ART REVIEW PANEL

MONTGOMERY COUNTY PLANNING DEPARTMENT

PROJECT: The Chevy Chase Center Collection
SITE PLAN No. 82001013C & 82001021E

*The Art Review Panel has generated the following meeting minutes based on our discussion of the design concept for the public amenities on **July 20, 2016** for the **Chevy Chase Center Collection (two Site Plan Applications)**. The Panel's recommendations should be incorporated into the Staff Report and strongly considered prior to the certification of the Site Plan and/or prior to the release of the first building permit. Should you have any additional questions and/or comments please feel to contact the Art Review Panel Coordinator.*

Figure 1: Subject Property (above)

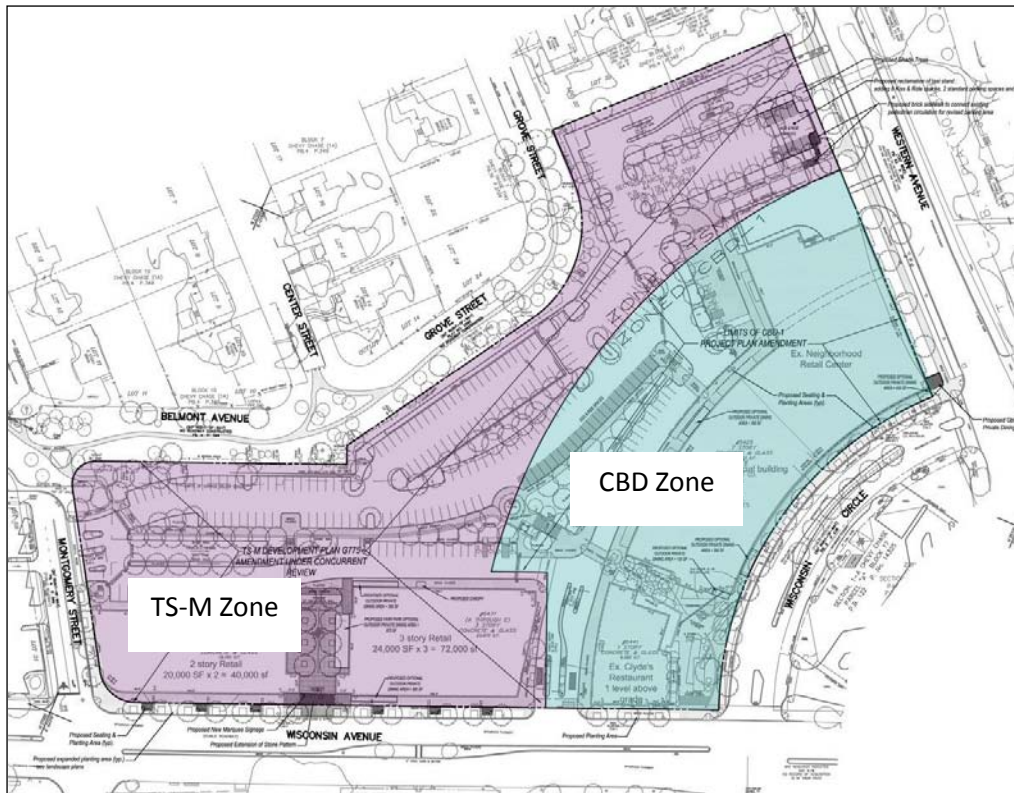
- The Applicant filed two Site Plan amendments in order to improve the streetscape design and renovate the public use spaces. The amount of public space is consistent with the previous approvals (CBD Zone = 22%; TS-M Zone 13%). Figure 1 below highlights the CBD and TS-M zones.
- There is no increase to the amount of public use space or density.
- The proposed density for both Site Plans is approximately 412,000 square feet.

- The Applicant is transforming the streetscape and public use spaces along Wisconsin Avenue and in order to be more inviting to pedestrians or cars passing by along Wisconsin Avenue, Wisconsin Circle, or Western Avenue.
